TOWN OF MONROE

APPLICATION REVIEW TEAM COMMENTS

PZC Application Number: SEP-2020-01, File #1621A **Comments By:**
Development Description: Double Drive-Through / Façade **P&Z Administrator** **Fire Marshal**
Location of Development: 390 and 400 Monroe Turnpike **Town Engineer** **Police**
Zoning – Assessor Map/Lot: B-2 – 30/9 and 10 **Building Official** **Health Department**
RM #1075 – 4 acres

DATE REVIEWED: **August 10, 2020**

1
A2.0
FRONT ELEVATION
1/4" = 1'-0"

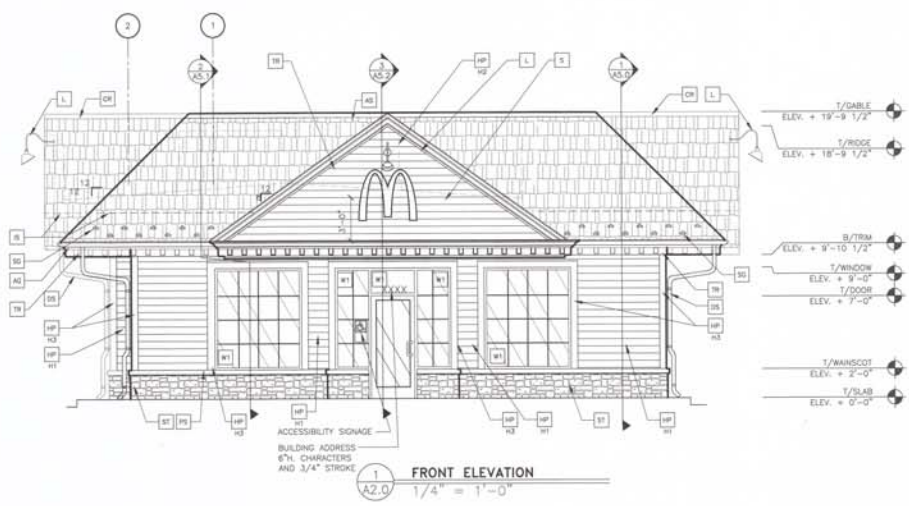
5. **Exterior Building Façade**
 - a. The proposed building exterior contemporary façade change is not consistent with the recommendations of the POCD or with the design standards in Zoning §7.2.6B and C. As the Commission may recall, when McDonald’s proposed a similar design in 2015 for a new facility at 579 Main Street (project was abandoned in 2018), the Commission worked with McDonald’s and approved instead a New England style design (see attached Elevations). The POCD would suggest a similar façade design here as well.
 - b. Notwithstanding the above, the following is otherwise suggested in regard to the contemporary design:
 - Use multi-colored natural fieldstone for the vertical elements rather than white eurowest tile.
 - Use pitched awnings instead of horizontal canopies to maintain some pitched roof element.
